Access Compliance Report

Public Rights-of-Way

(Curb Ramps)

Intersection ID: 10028	Main Street: STARHAVEN_DR	Cross Street: THE_PLAZA	Location: SE
ADA ID: 7D532BA1FC3C	Ramp Type: PerpDiag	Initial Pass/Fail: Fail	Overall Compliance: No
Codes/Mitigation Info/Possible Solution		Field Measurements/Component Compliance	
Severity Score: 12.5

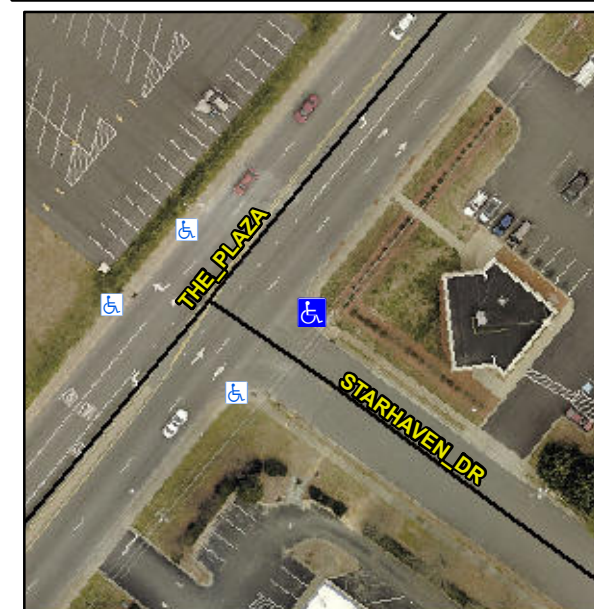
Not Found, R304.2.2

Compliance	Description	Data	Compliance	Description	Data
N/A	Ramp Length (in)	60.0	No	Ramp Slope (%)	8.6
Yes	Ramp Width (in)	48.0	Yes	Ramp XSlope (%)	0.2
N/A	Flare Type LT	N/A	N/A	Flare Type RT	N/A
N/A	Flare Slope LT (%)	N/A	N/A	Flare Slope RT (%)	N/A
N/A	Flare Traversable LT?	N/A	N/A	Flare Traversable RT?	N/A
N/A	Landing Length (in)	N/A	N/A	DWS Provided?	N/A
N/A	Landing Width (in)	N/A	N/A	DWS Contrast?	N/A
N/A	Landing Slope (%)	N/A	N/A	DWS Length (in)	N/A
N/A	Landing X Slope (%)	N/A	N/A	DWS Full Width?	N/A
N/A	Landing Curb? (Y/N)	N/A	N/A	DWS Offset (in)	N/A
N/A	Shared Landing?	N/A			
N/A	Gutter Ponding?	N/A	N/A	Gutter Slope (%)	N/A
N/A	Gutter Lip Ht (in)	2.0	N/A	Gutter X Slope (%)	N/A
N/A	Painted X Walk1?	No	N/A	Painted X Walk2?	No
	X Walk 1 Direction	To NW		X Walk 2 Direction	To SW
N/A	X Walk 1 Width (in)	N/A	N/A	X Walk 2 Width (in)	N/A
	X Walk 1 Slope (%)	2.1		X Walk 2 Slope (%)	1.3
	X Walk 1 X Slope (%)	1.1		X Walk 2 X Slope (%)	0.5

Remove & Replace Curb Ramp With Two New Directional Ramps or Equivalent.
